PROJECT: WEST PREP ACADEMY ELEM. SCHOOL ADDITION

SUBMITTAL: 1ST

CITY OF LAS VEGAS		DATE:
INTER-OFFICE MEMORANDUM		August 26, 2015
TO: Land Development Services Department of Building & Safety		FROM: Albert Sung, P.E. Flood Control Project Engineer Department of Public Works
SUBJECT:	Drainage Study for:	
	West Prep Academy Elementary School Addition	
Cross Streets:	SEC of Lake Mead Blvd. & Pink Rose St.	
File Number:	F:\Depot\DSMemos\DS4747A.doc	
Parcel Number:	139-21-314-001	
Zoning Action:	PMP-60740	
FEMA Flood Zone	YES	NO X
Proposed Storm Drain	YES	NO X
		COPIES TO: GCW Engineers Surveyors Clark County School District Bart Anderson, P.E., DevCo CCRFCFCD CNLV

FOR CONTINUATION SEE SHEET NO. C10

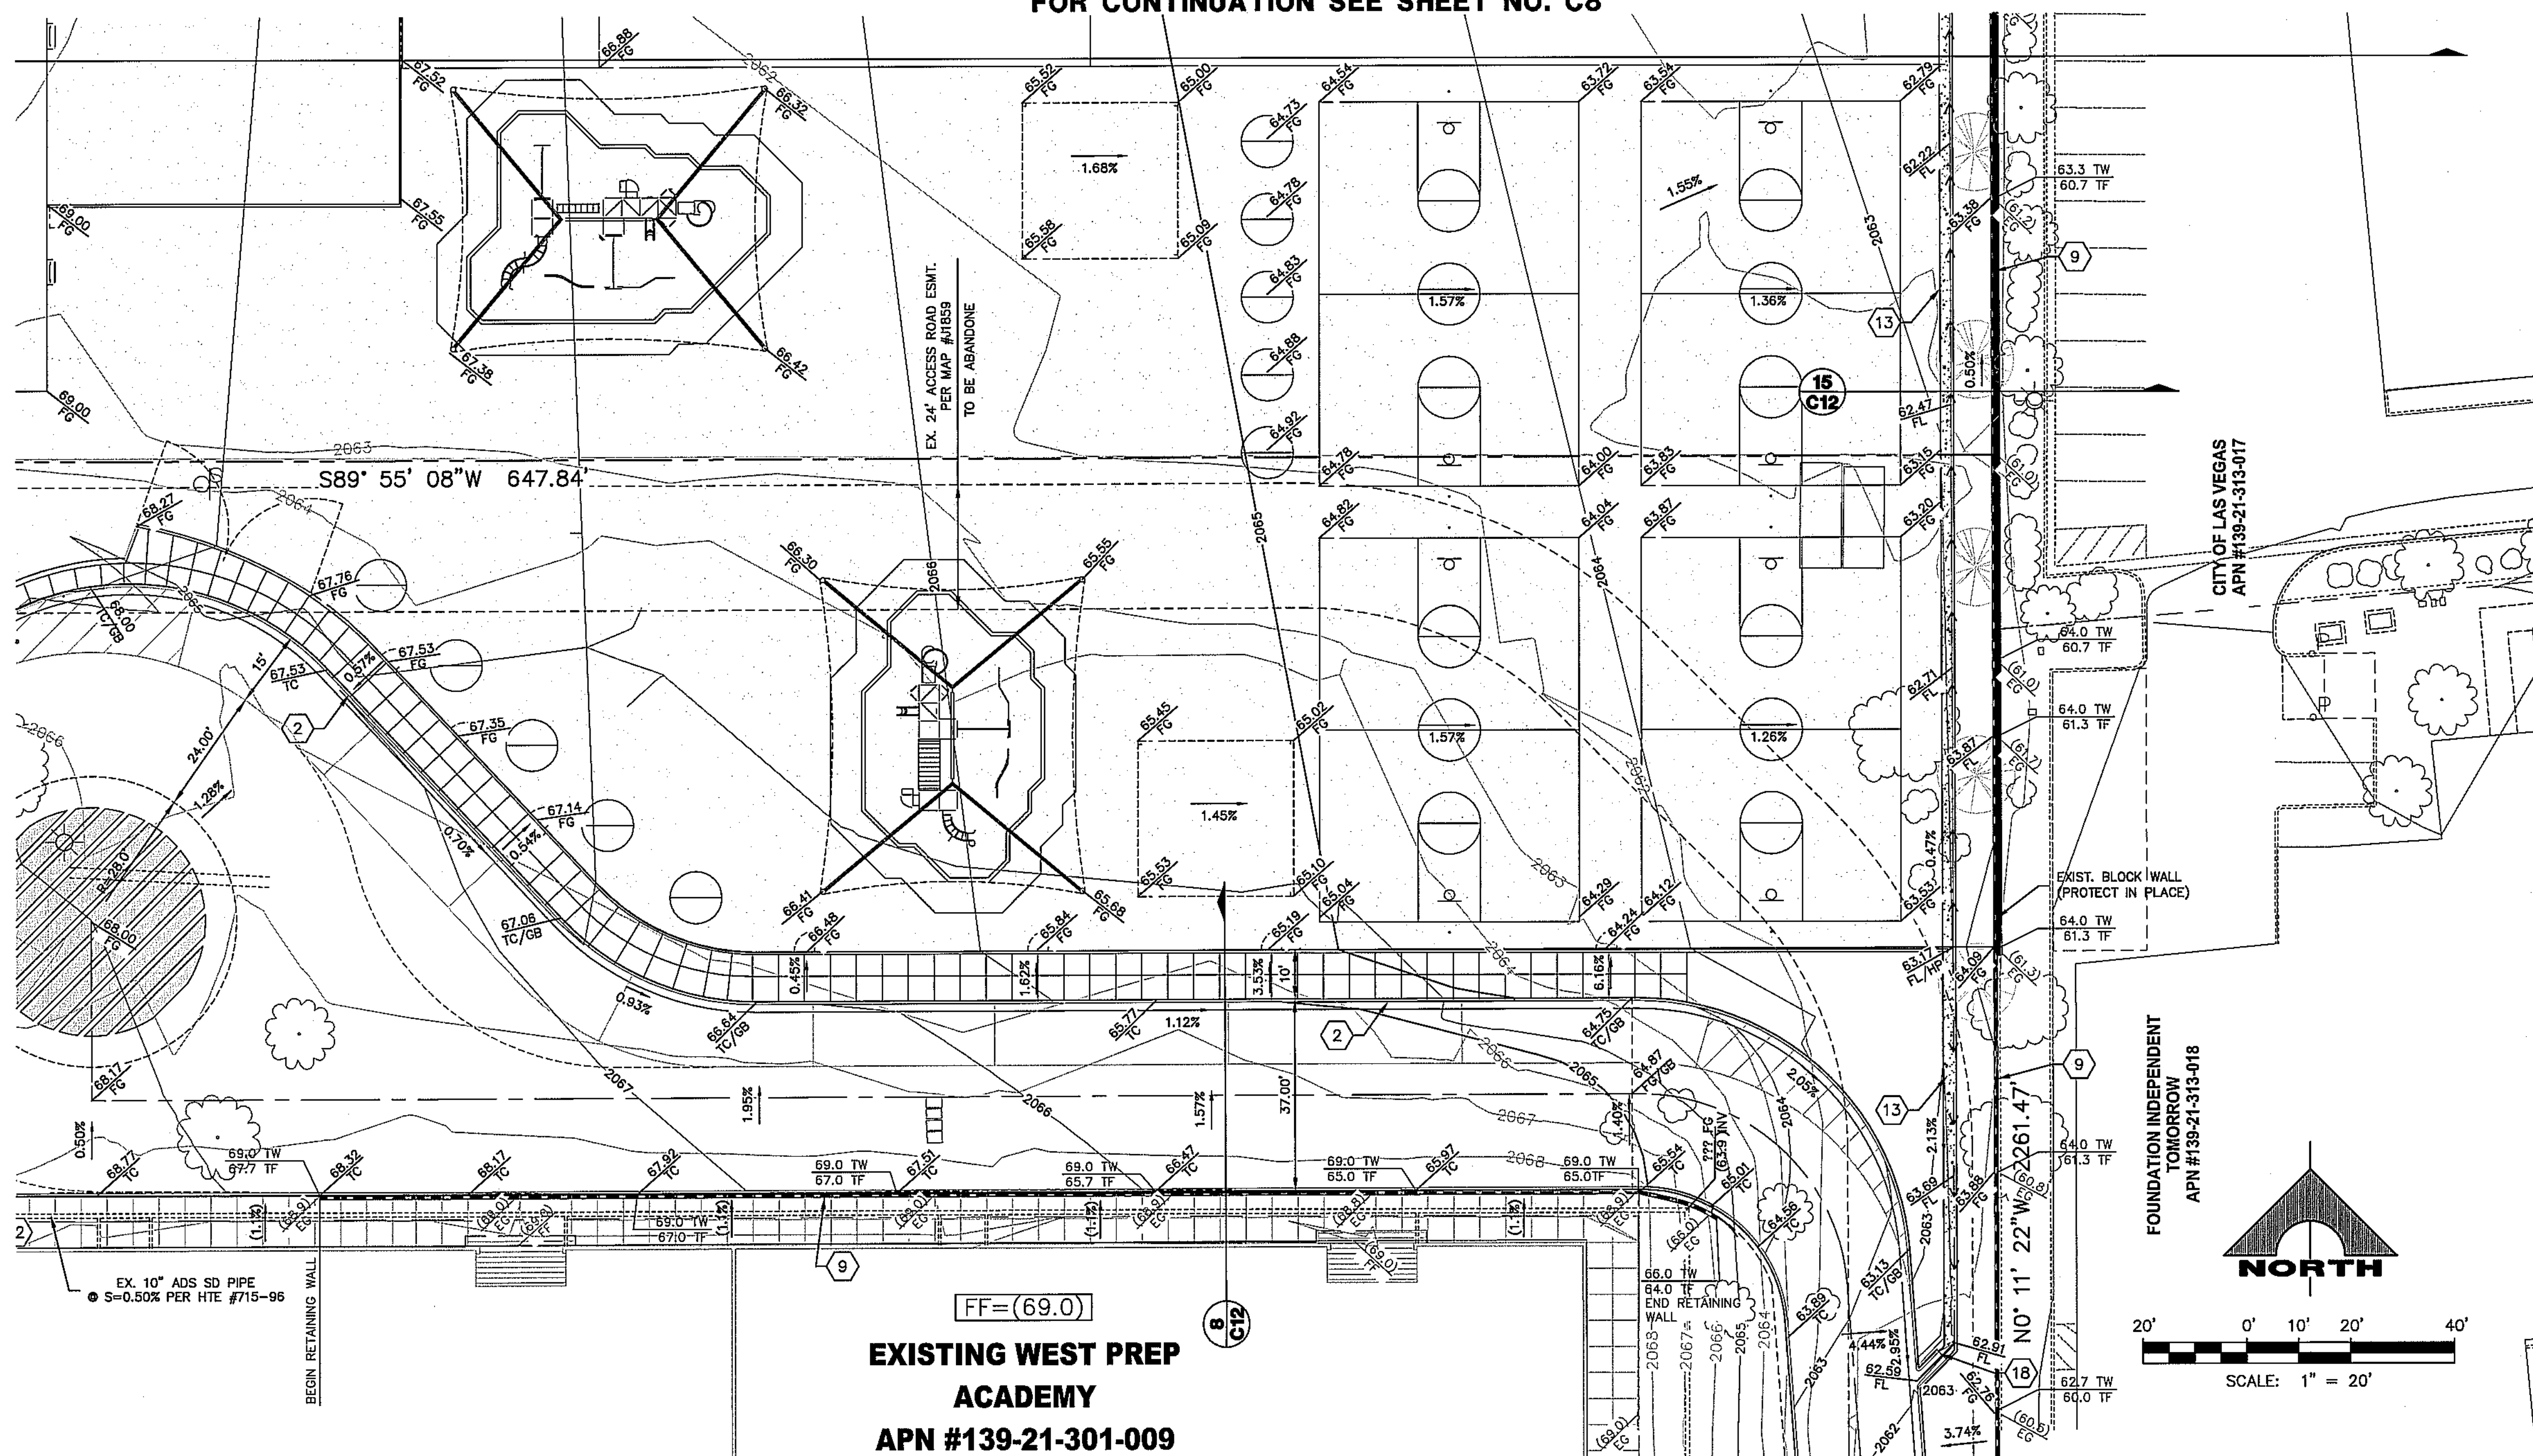
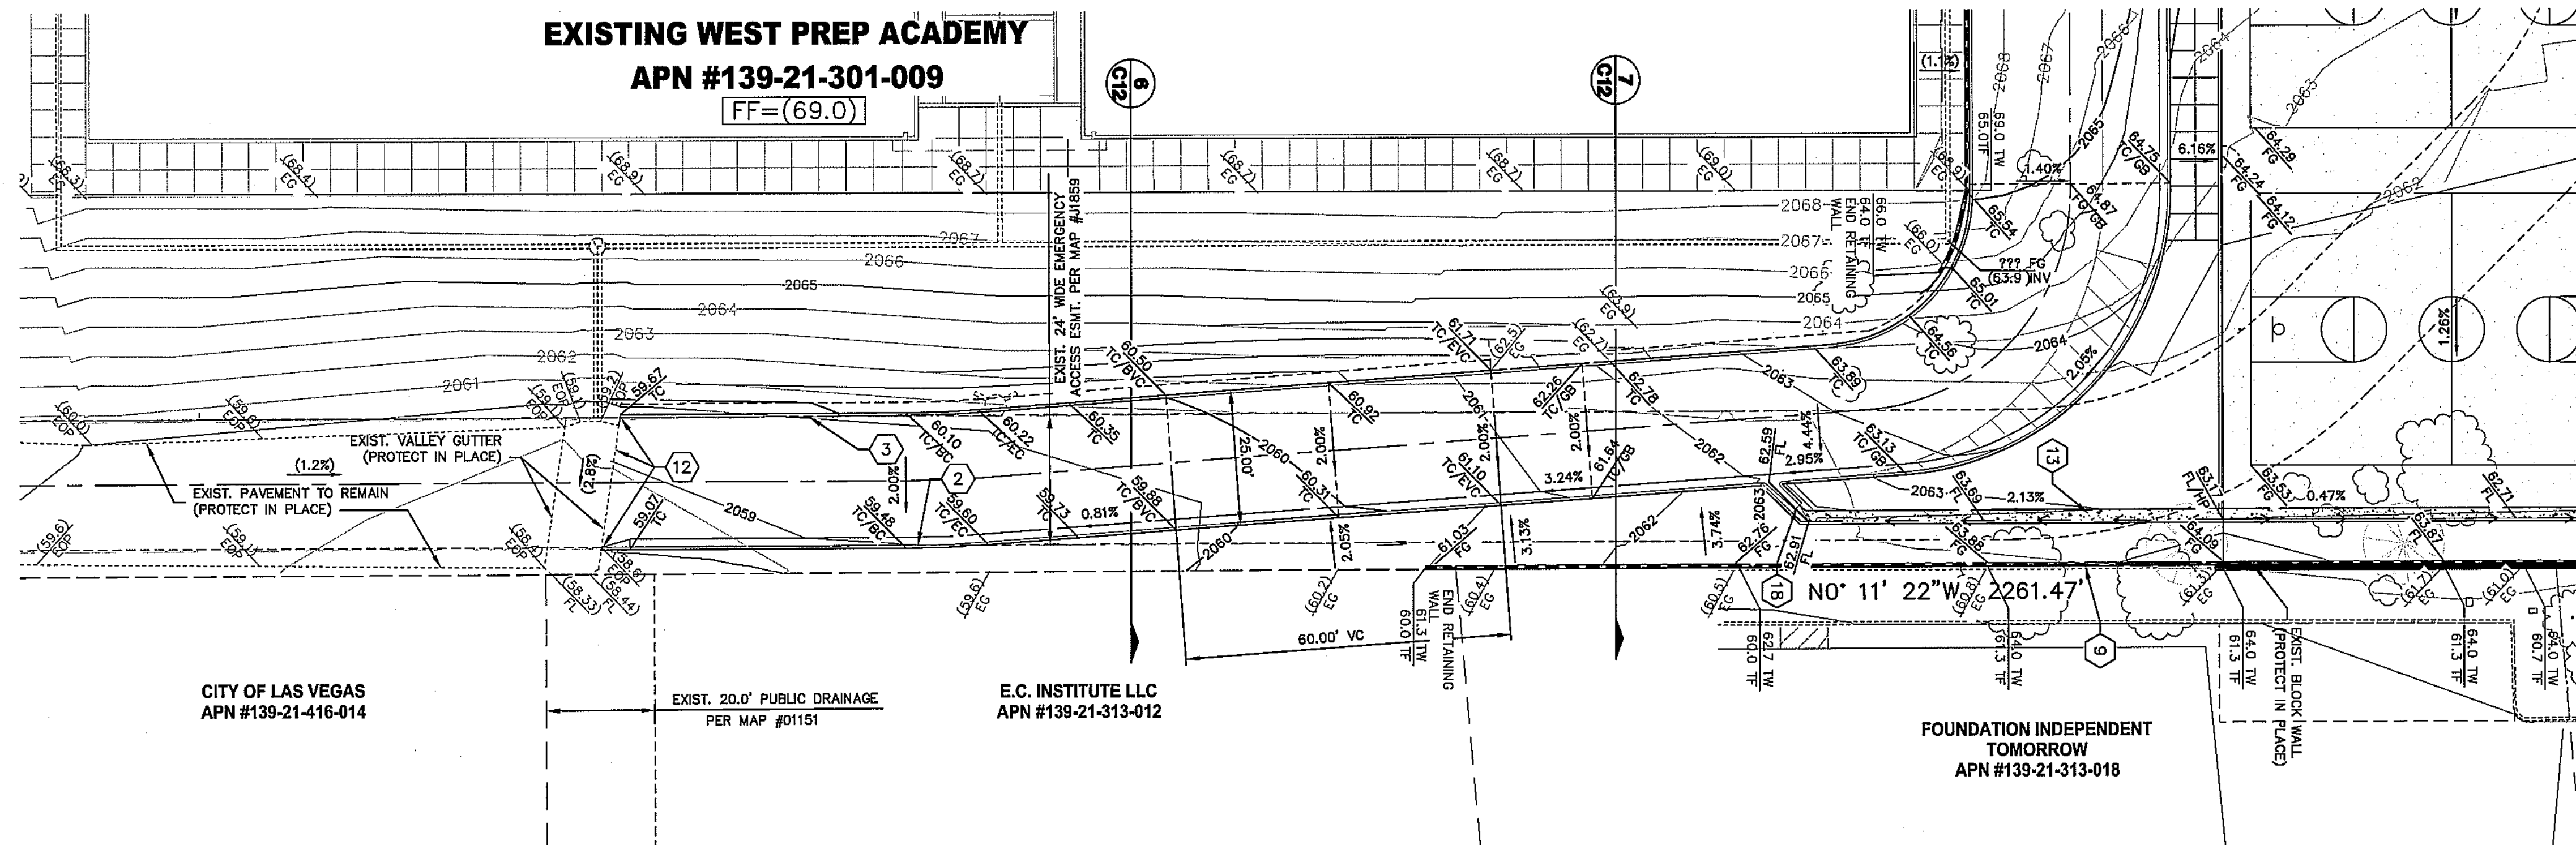
7. **Sheet C10:** During a worst case scenario that the trench grates are clogged, the resulting drainage will be on surface in the corridor between the new and the existing school buildings. The water surface appears will be inundating the adjacent buildings. Please address this in the next submittal.
